Re: Town of Hilton Head Island, SC
2016 Beach Renourishment Project
IFB 2015-0023 – Addendum #4

ADDENDUM No. 4

**TOWN OF HILTON HEAD ISLAND, SC
2016 BEACH RENOURISHMENT PROJECT**

SHEET
25
 of 27

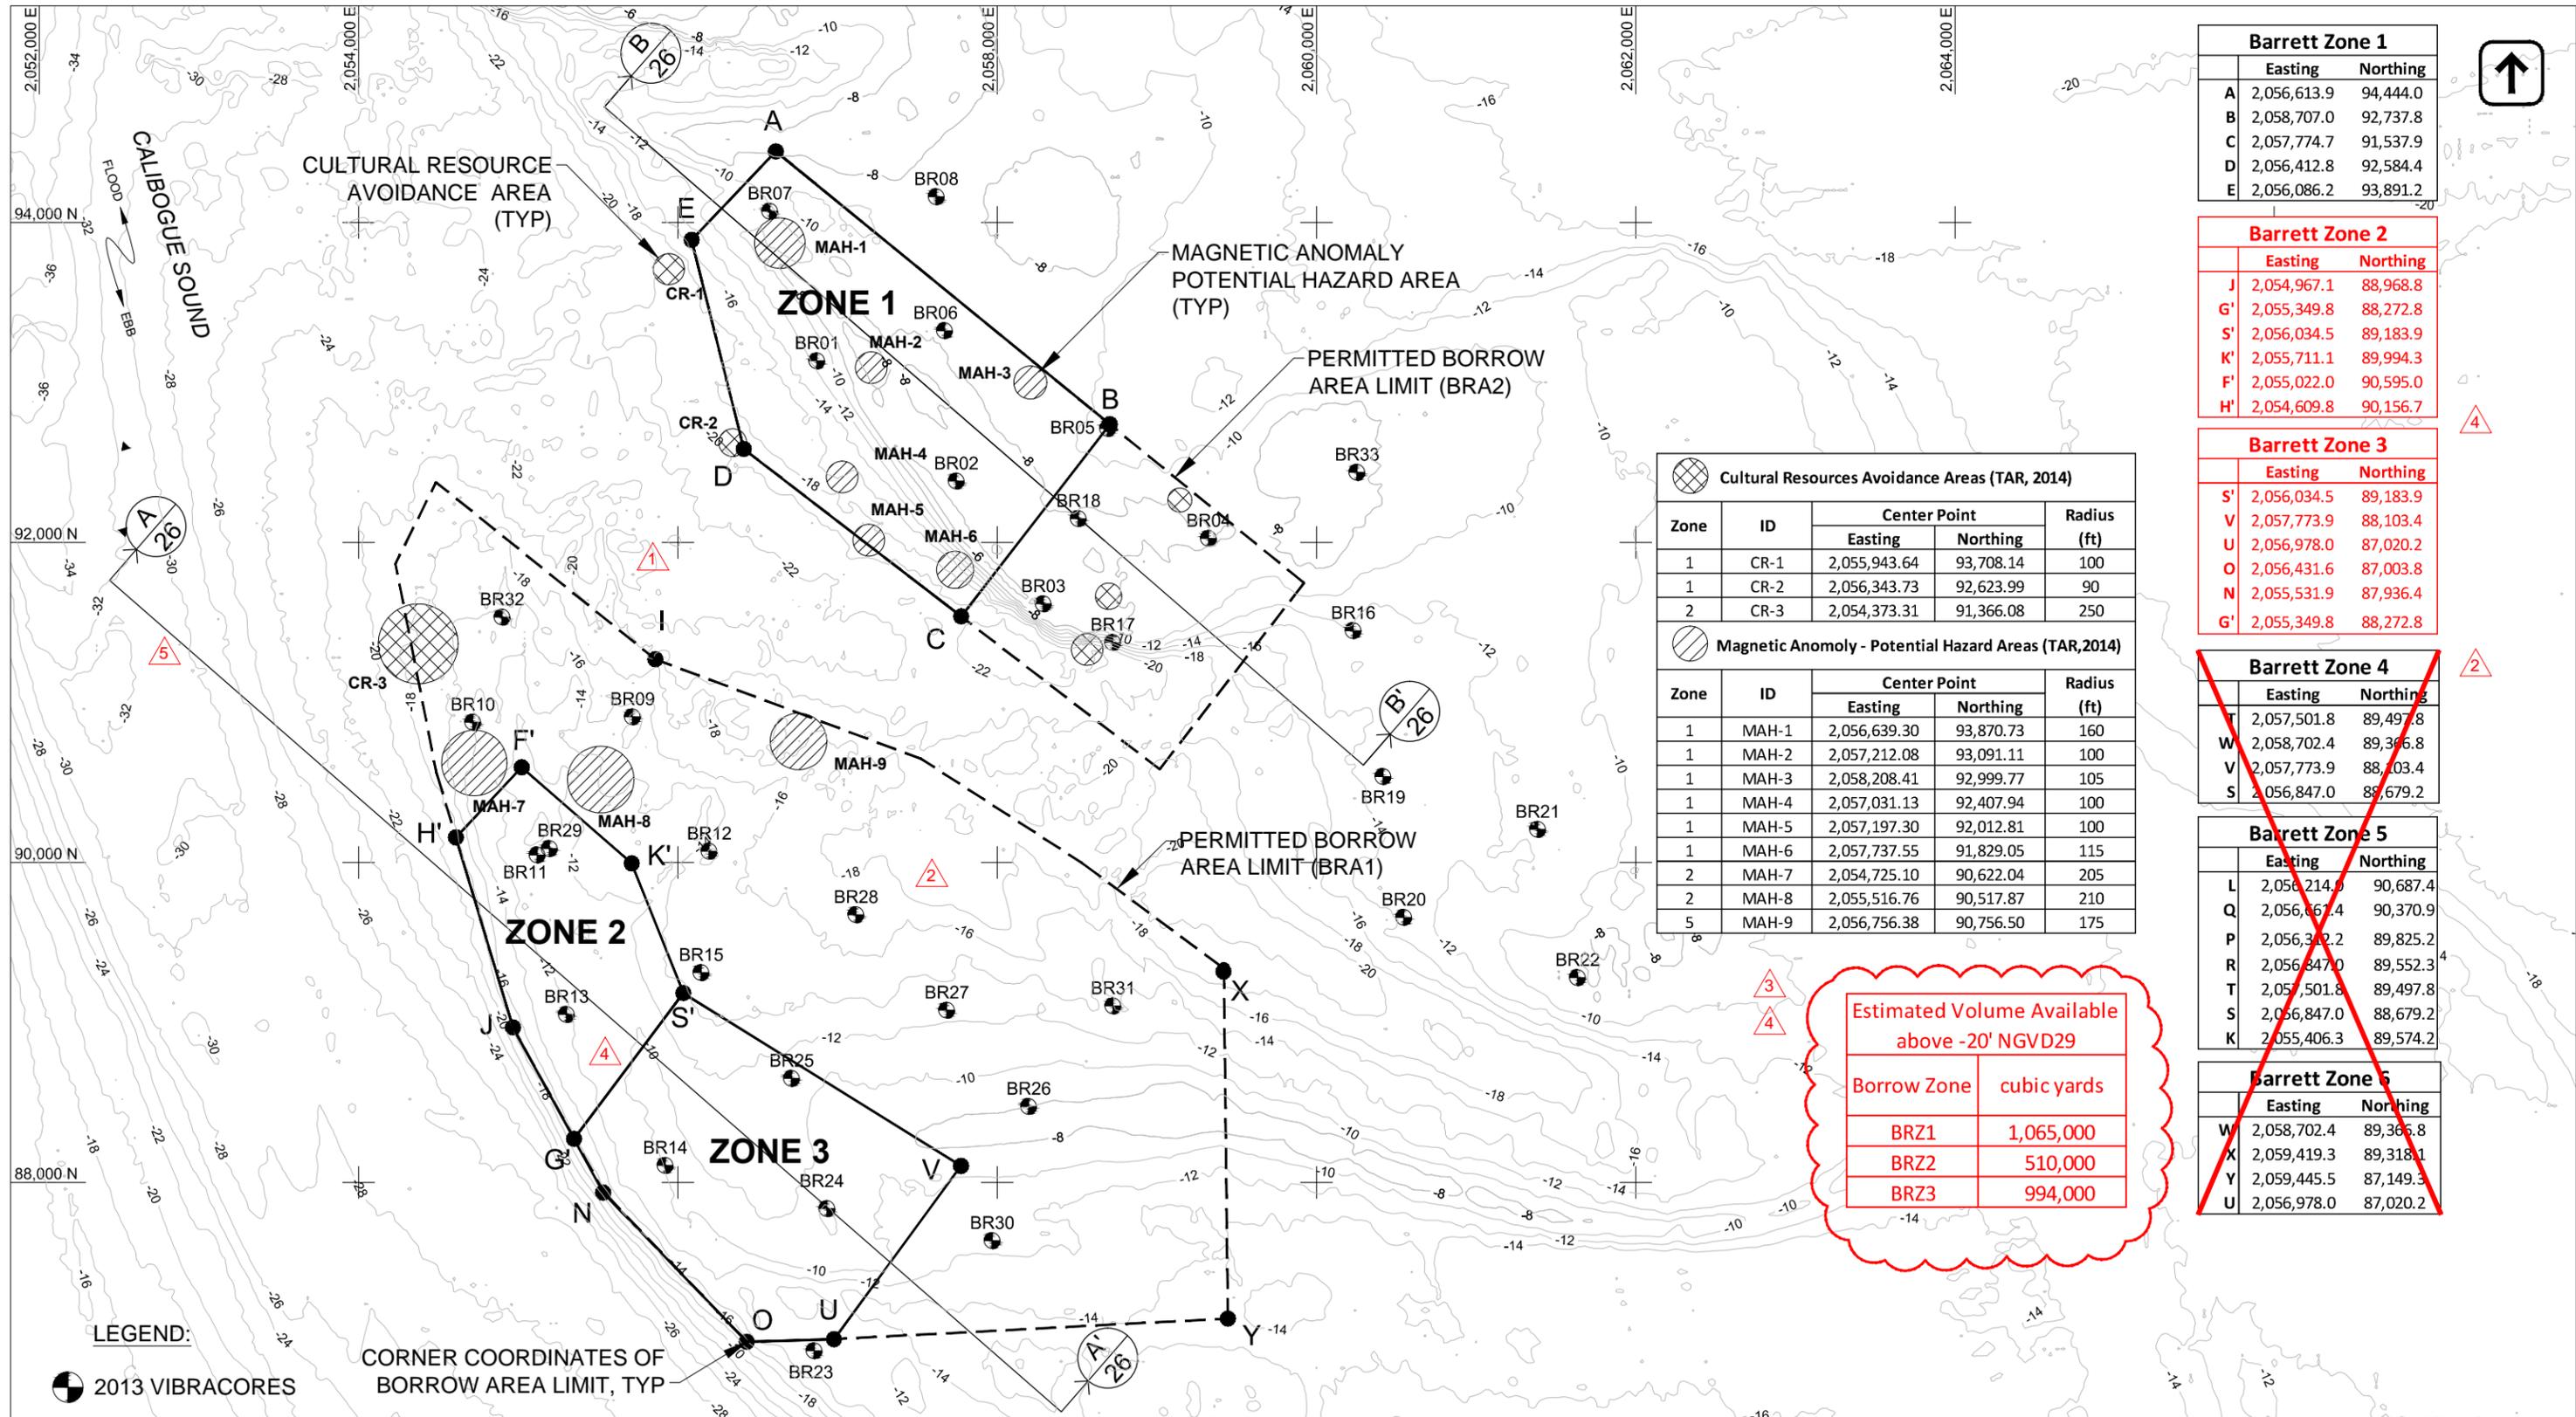
- R.4.)** **Construction Plans, Sheets 25 of 27 and 27 of 27:** Borrow Area Zones at the Barrett Shoals Borrow Area have been revised. Sheets 25 and 27 of the Construction Plans dated August 19, 2015 and revised on September 3, 2015 are hereby replaced in their entirety by the attached, updated Sheets 25 and 27, dated September 15, 2015.

REVISIONS				
LTR	DESCRIPTION	BY	DATE	APPRVD
1	CORRECTED CONTOURS TO NGVD29	PS	9/3/15	CGC
2	REVISED BORROW AREA	PS	9/3/15	CGC
3	REVISED ESTIMATED VOLUMES IN ZONES 1, 2, & 3	PS	9/3/15	CGC
4	REVISED BORROW AREAS TO AVOID CR AND MAH AREAS	PS	9/15/15	CGC
5	REVISED LOCATION OF SECTION A-A'	PS	9/15/15	CGC

SHEET
27
 of 27

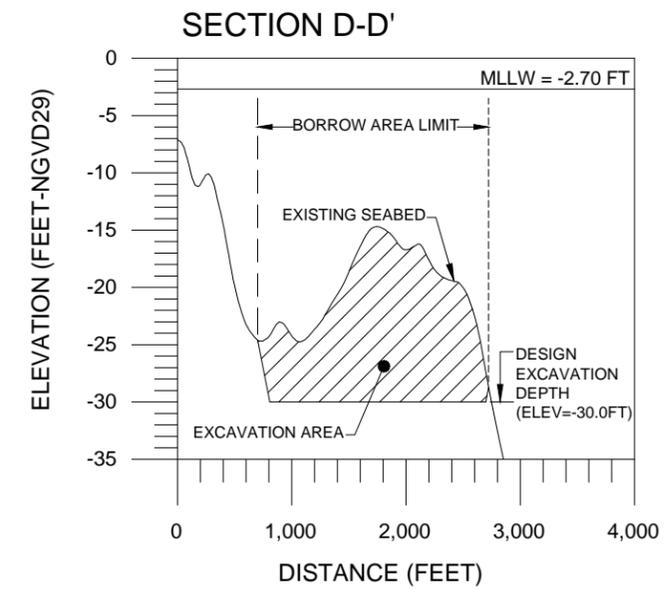
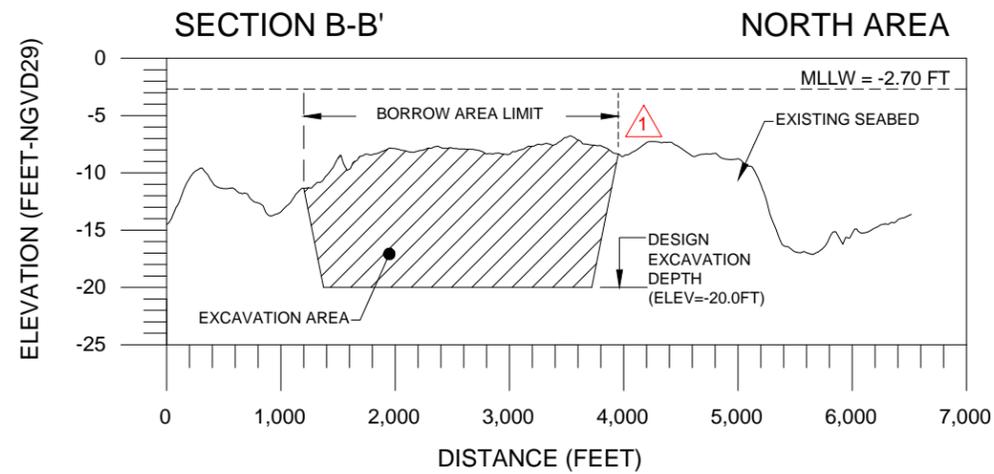
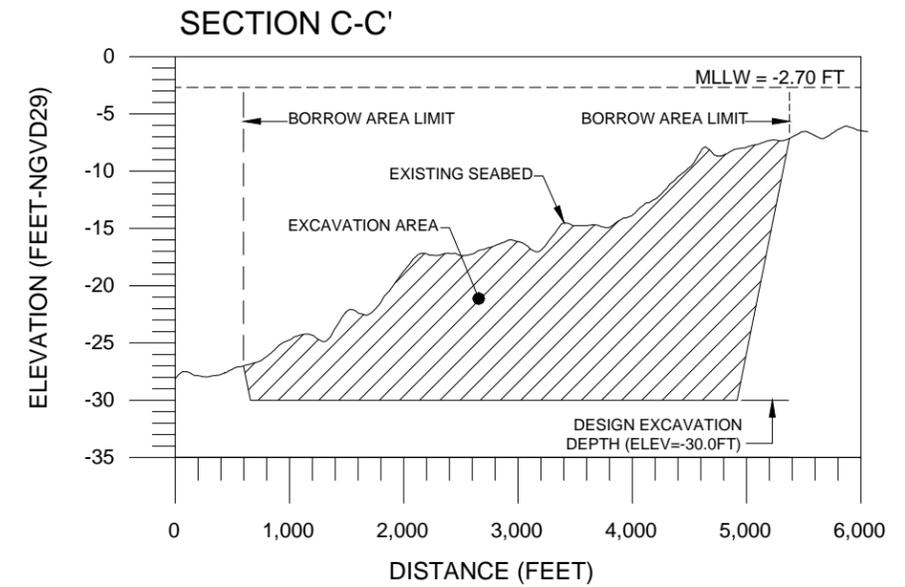
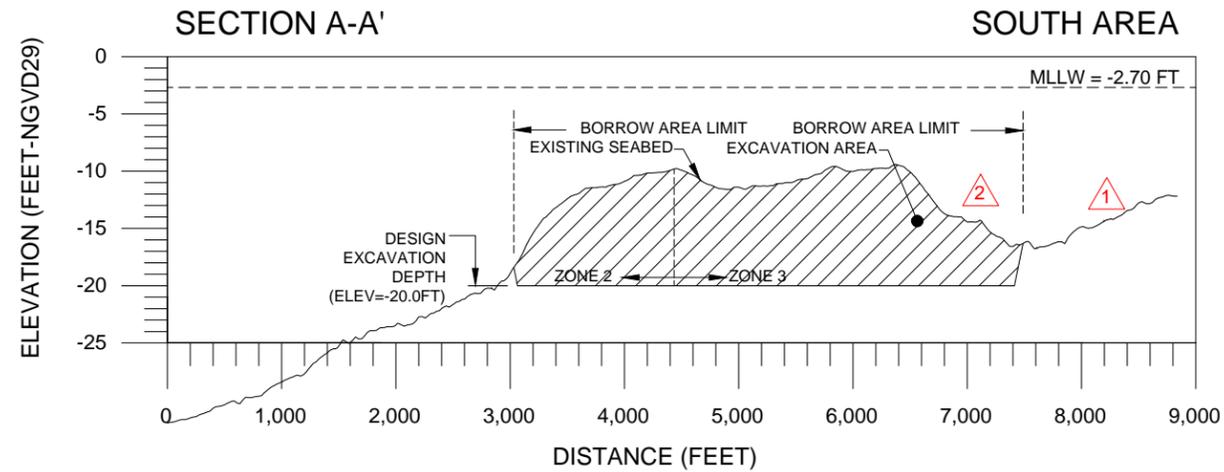
Q.14.) Allowable over-dredge: Sheet 27 of the project plans show a design excavation depth of -20.0 feet and -30.0 feet, NGVD29 for the Barrett Shoals and Bay Point Shoals borrow areas, respectively; however, no design allowable over-dredge depth is shown on this sheet. Conversely, Page 19 (of 21) of the OCRM permit illustrates 2.0 feet of design allowable over-dredge depth for both borrow areas. Per the OCRM permit, can the Engineer please confirm that the Contractor will be granted 2.0 feet of design allowable over-dredge depth to account for inaccuracies in the dredging process?

REVISIONS				
LTR	DESCRIPTION	BY	DATE	APPRVD
1	CORRECTED CONTOURS TO NGVD29	PS	9/3/15	CGC
2	REVISED LOCATION OF SECTION A-A'	PS	9/15/15	CGC

- Maximum allowable dredging depth is the design excavation depth shown in the Plans. That is, -20 ft NGVD29 at Barrett Shoals and -30 ft NGVD29 at Bay Point Shoals. The Contractor shall view this maximum allowable dredge depth as the absolute lower limit of excavation. The design excavation depth shown in the plans represents the elevation below which no sediments shall be disturbed by the dredging process. No allowable over-dredge depth is provided. It is

acknowledged that the final surveyed depths in the borrow areas may be shallower than the design excavation depth as a result of this requirement.
